McKinley Grade Separation Peer Review Ad Hoc Committee

PEER REVIEW TEAM REPORT

March 20, 2019

- Underpass or Overpass

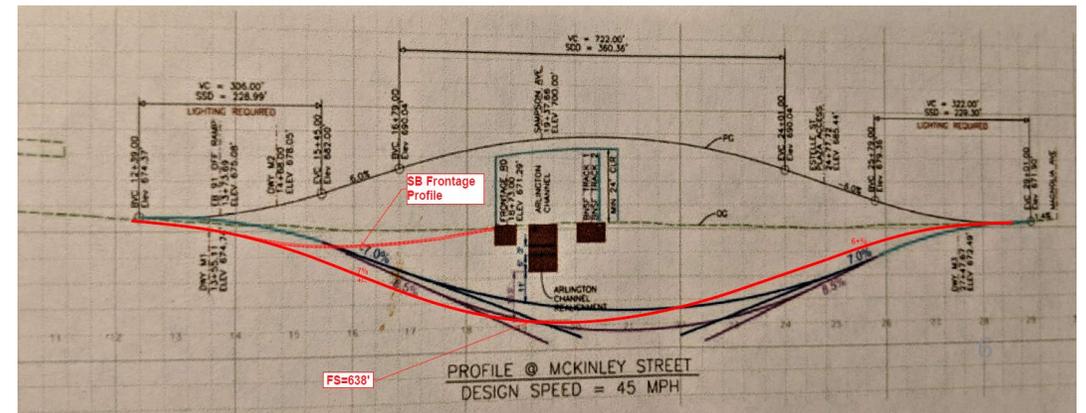
Underpass meets these if it works geometrically within cost

Milliken Avenue Track Flyover

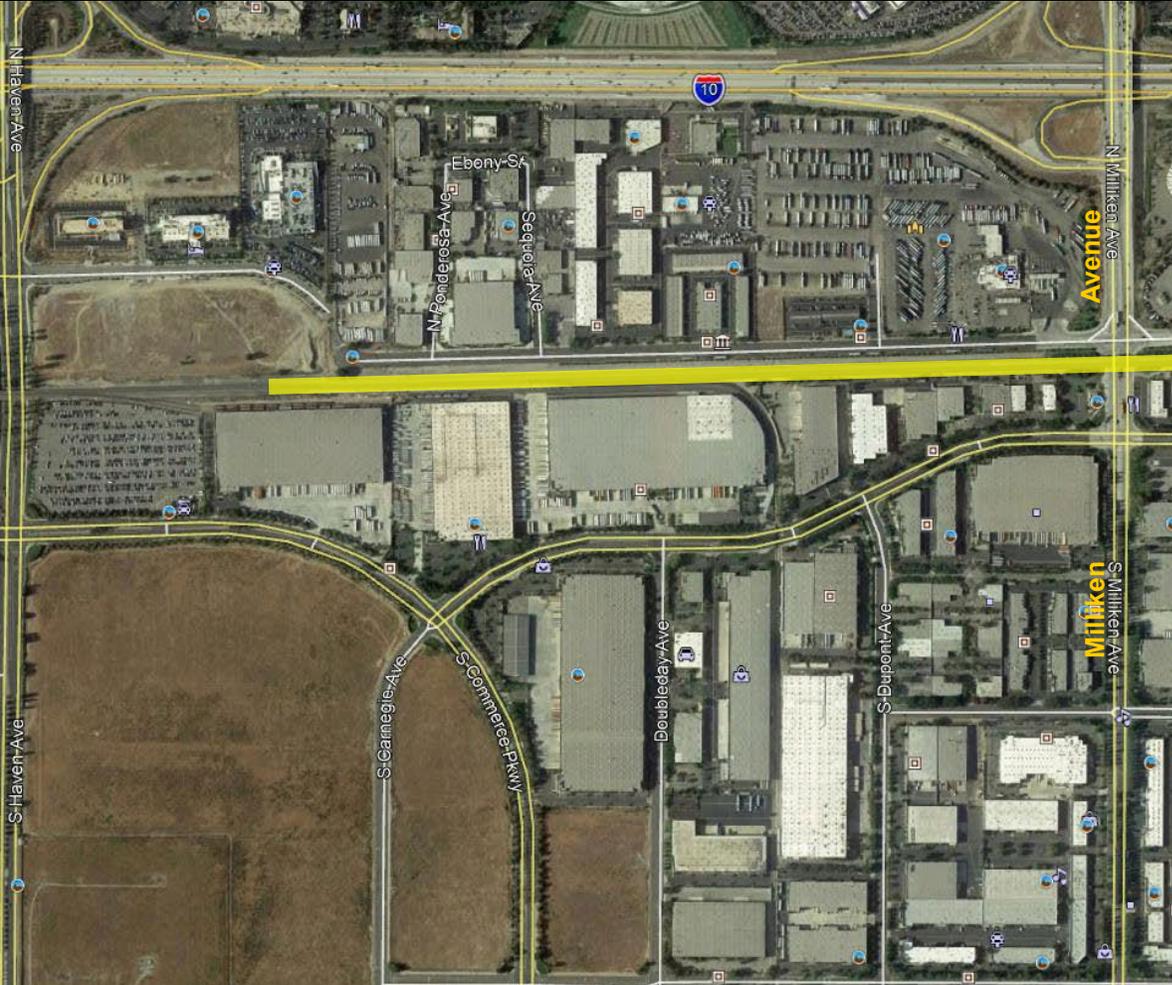
- Milliken Av. Project Details:**
- Existing Single Track Segment (UPRR Alhambra Sub.)
 - 52' Wide Track Flyover for 2 Tracks
 - Approx. 1.4 miles
 - Single Track Shoofly within RR ROW
 - **Approx. Cost: \$49M**

- McKinley St. Project Details:**
- Existing Double Track Segment (BNSF San Bernardino Sub.)
 - 100' Wide Track Flyover for 4 Tracks
 - Approx. 1.70 miles
 - Double Track Shoofly possibly outside RR ROW (\$80-120M)
 - **Approx. Cost: \$174M-206M**
 - Channel Reinforcement Needed
 - ROW Costs (\$75-\$110M)
 - Timely Completion Concerns

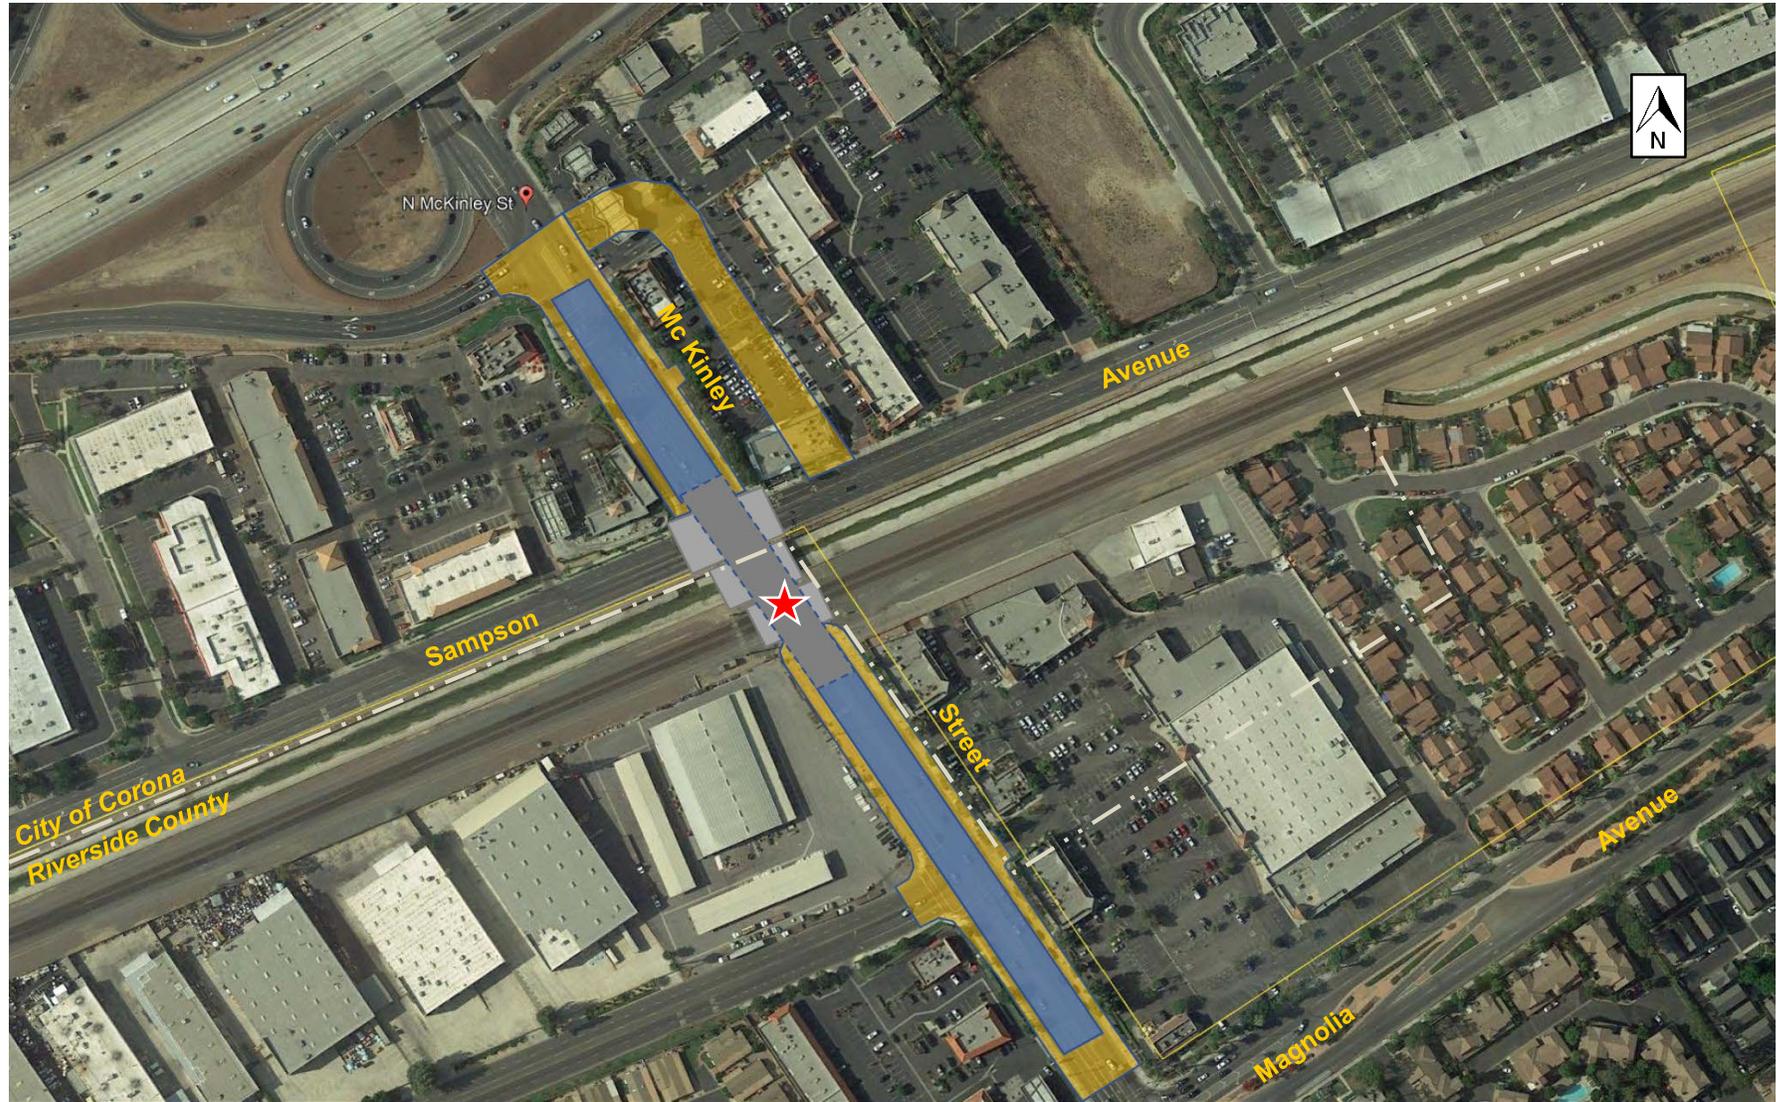
- **Lack of Design Sequence and Screening**
- **Meet BNSF Requirements without Exception**
- **High Right of Way Cost**
- **High Overall Cost Compared to Similar Projects**
- **Focus on Innovation vs Scope & Cost Control**
